SONY

Technical News

Ref. No.	Issuer company	Issue (yyyy/mm/dd)	Last modificat	Last modification (yyyy/mm/dd)		
PV20NEX506	Digital Imaging Group	2020/06/29	2020/11/12	2020/11/12		
Subject						
counter measures for screws loose						
Model (System model)	Destination	Serial number		Color		
SEL200600G	All	~	1844842

Screws Looseness in filter screw frame and body mount in the market

*1 Service Manual Level 2 2-3-32. FILETR SCREW RING ASSY

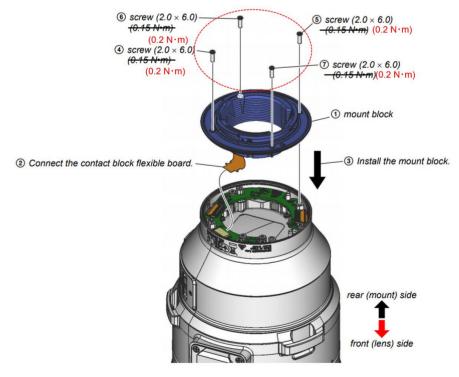
Location of Parts	Before	After improvement
Screws for filter ring screw *1	1P2X6C3CIB (4-696-871-01) tightening torque 0.15 Nm	1P2X6.5C3CPAS (5-022-026-01) tightening torque:0.2Nm
Screws for mount block *2	1P2X6C3C NYLOK (5-006-464-01) tightening torque:0.15Nm	
Screws for tripod plate *3 2	LOCK, 2P2X7C3C IB 5-008-351-01 tightening torque:0.15Nm	LOCK, 2P2X7C3C IB 5-008-351-01 tightening torque: 0.2Nm
Screws for tripod ring *4 $\sqrt{2}$	LOCK,TRIPOD SLIDING PIECE 5-005-671-01 tightening torque:0.15Nm	LOCK,TRIPOD SLIDING PIECE PAS 5-005-671-02 tightening torque: 0.2Nm
Screws for tripod ring fitting tube *5 2	SCREW, 1 GROUP PIECE 5-005-668-01 tightening torque:0.12Nm	SCREW PAS,TRIPOD RING FITTING 5-024-628-01 tightening torque:0.15Nm
